IMPROVED DUAL ADJUSTABLE BIAS FOR ORIGINAL HIWATT DR103 35VAC TRANNY WINDING (QUAD EL34)

DATED 01-05-2020 REV.0 BY RENÉ MIKKERS

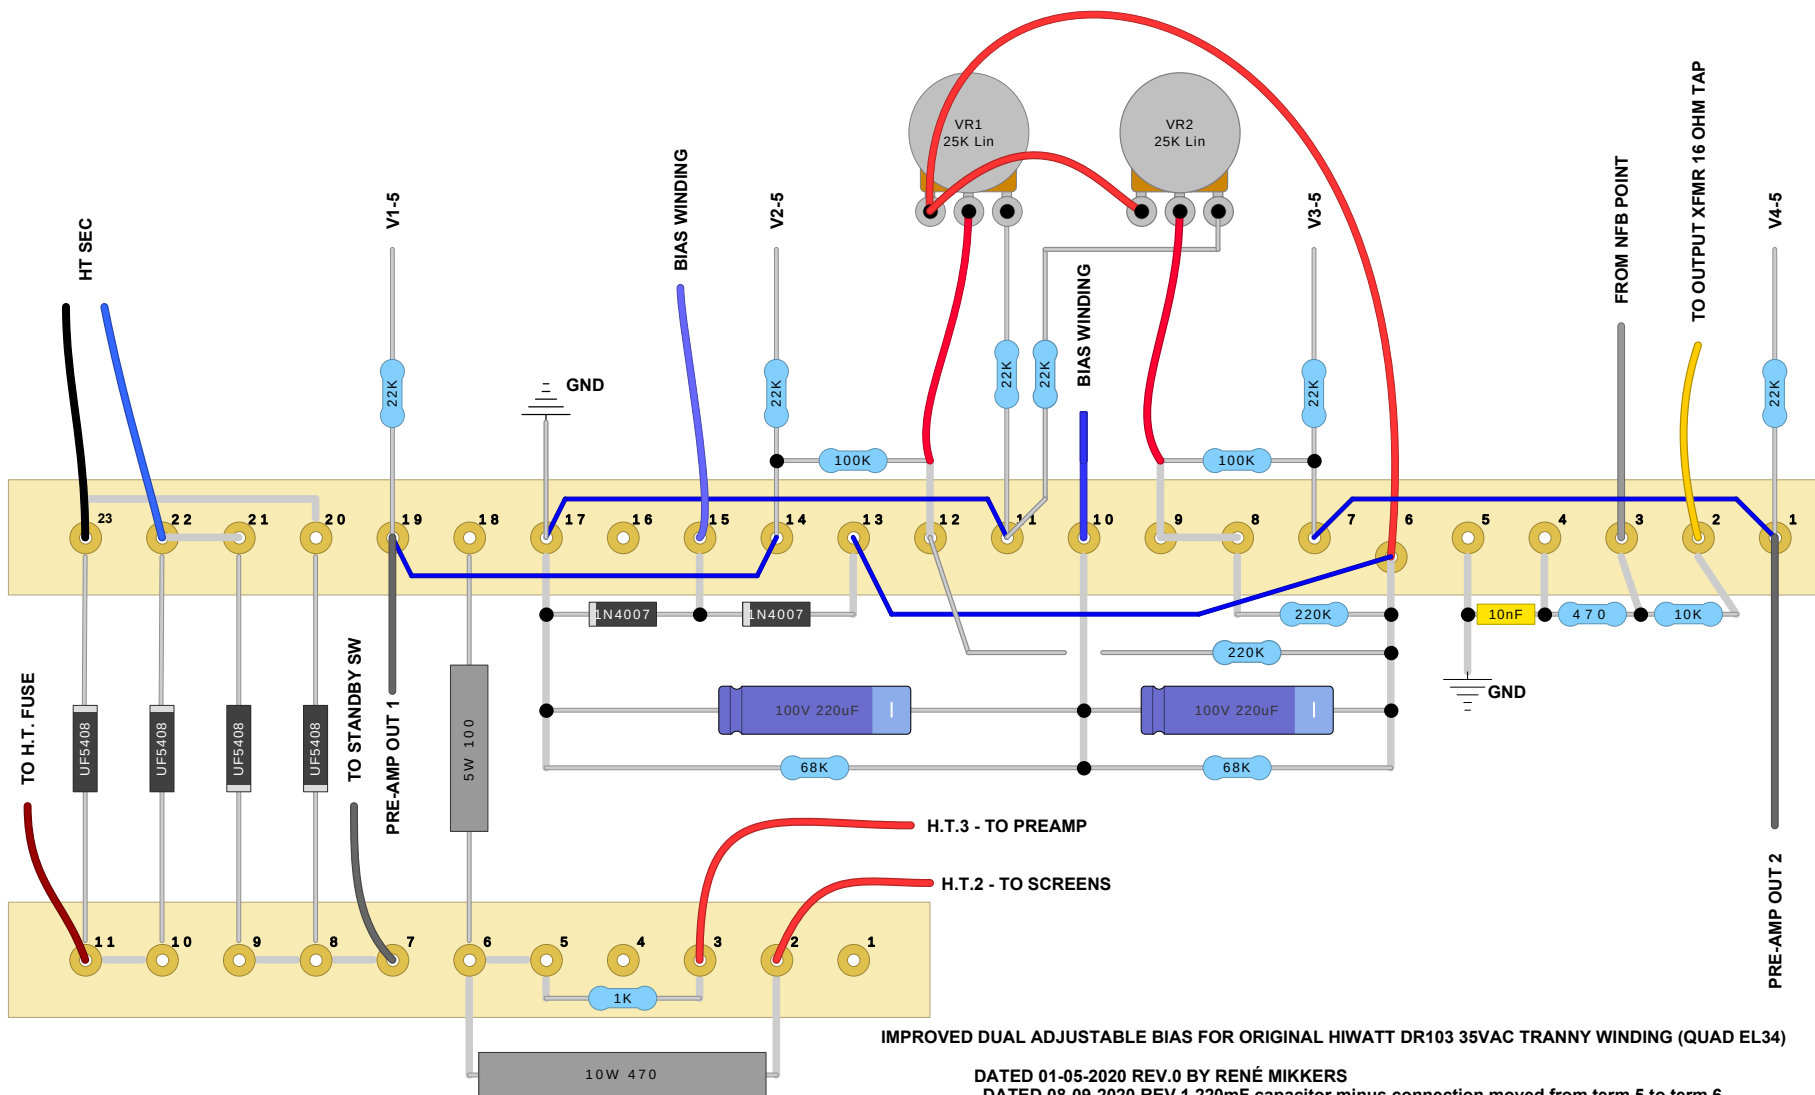
DATED 08-09-2020 REV.1 220mF capacitor minus connection moved from term 5 to term 6
